Rio Grande Floodway Project
General Reevaluation Report and
Supplemental Environmental Impact Statement
Independent External Peer Review (IEPR), Phase 1

Final IEPR Panel Comments, USACE Responses,
and IEPR Panel Backcheck Comments

July 25, 2012

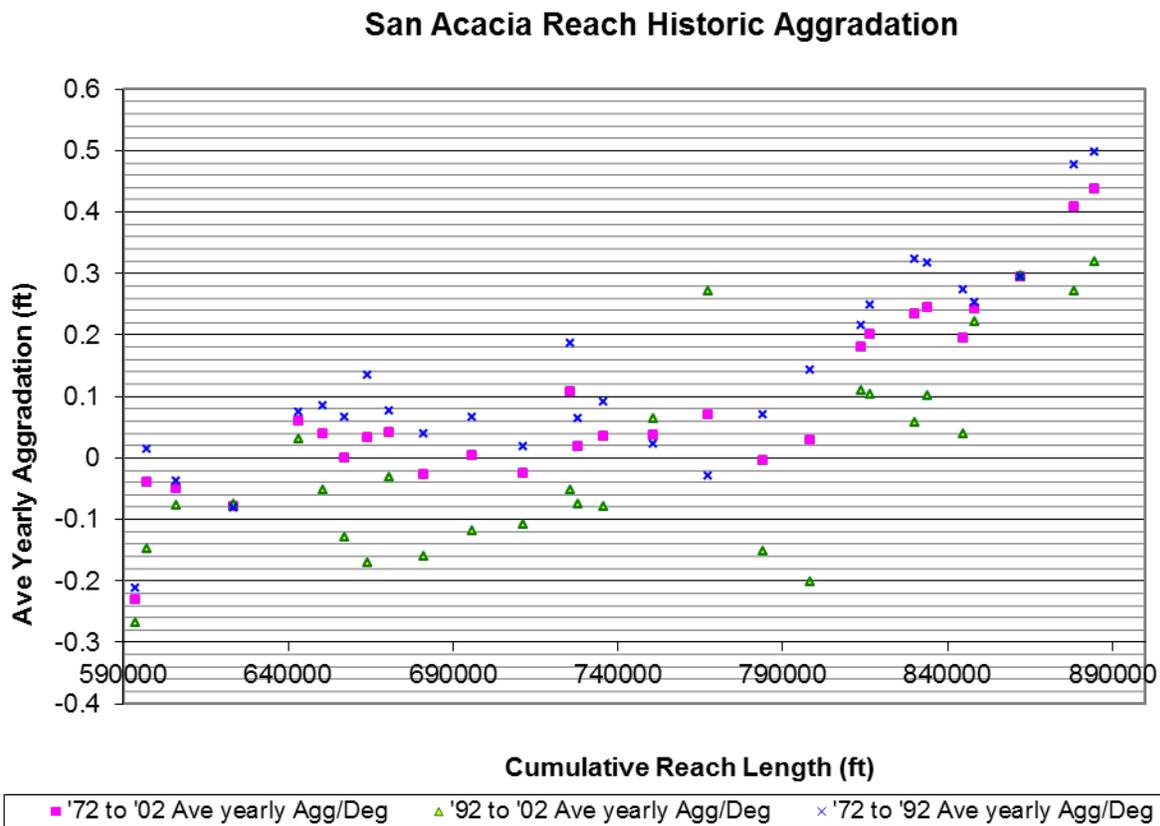
Comment #8:
The levee details do not correspond to the GRR/SEIS.
Basis for Comment:
The GRR/SEIS should identify levees <5 ft in height will be constructed and provide a cross-section. It appears that Section A is for 5–12-ft-high levees and Section B is for greater heights, but this is not stated anywhere in the GRR/SEIS. Also, details on ancillary structure layouts, e.g., Brown Arroyo gates, Railroad Bridge, etc., would be helpful to understand what is planned. The report provides descriptions but no drawings.
Significance: HIGH
Need to identify where the various types of levee construction will occur. This would help to understand where the levees may be the most impacted, in terms of depth of water against the levee.
Recommendation for Resolution:
Add detail drawings to the report or appendix. A. Show all three types of levee construction, and how the <5-ft height levees would be constructed, including foundation and compaction. B. Treatments. Clarify what the other two cross-sections represent height-wise, and check against the verbal descriptions to match the graphical representation, e.g., toe drains will be one-third the base of levee width. Indicate on the plan view sheets which levee section is needed for each reach. C. Show preliminary layouts for levee openings, tie backs, sediment basins, and other significant cost facilities. Include O&M requirements, as appropriate. D. Show alignment and profile for the new Railroad Bridge, and graphically show how the bridge hydraulics and sediment transport issues are addressed. There is a verbal description, but it is difficult to visualize the facility and its location. Also discuss and show what will happen to the existing structure, and any cultural values.

USACE Evaluator Response (#8):
Concur - Levee superiority has redefined the levee’s vertical alignment since the GRR went out for review. A. Not Adopt: The new refined levee is greater than 5’ for the whole levee alignment and will be further refined during plans and specs. Therefore, a typical section for a levee less than 5’ is not required. A spreadsheet showing the difference in vertical height is available upon request. B Adopt Later: The station reaches, for the various typical sections, has been further refined in the technical appendix. C. Adopt Later: The ancillary structures mentioned have also been included and refined in the

D. **Not Adopt:** The Railroad bridge replacement measure was screened out early in formulation therefore additional analysis and discussion is not warranted.

Concur, since the proposed changes (items B and C) will be addressed in the final draft GRR/SEIS. References should be included in the main text when information is presented in the appendices.
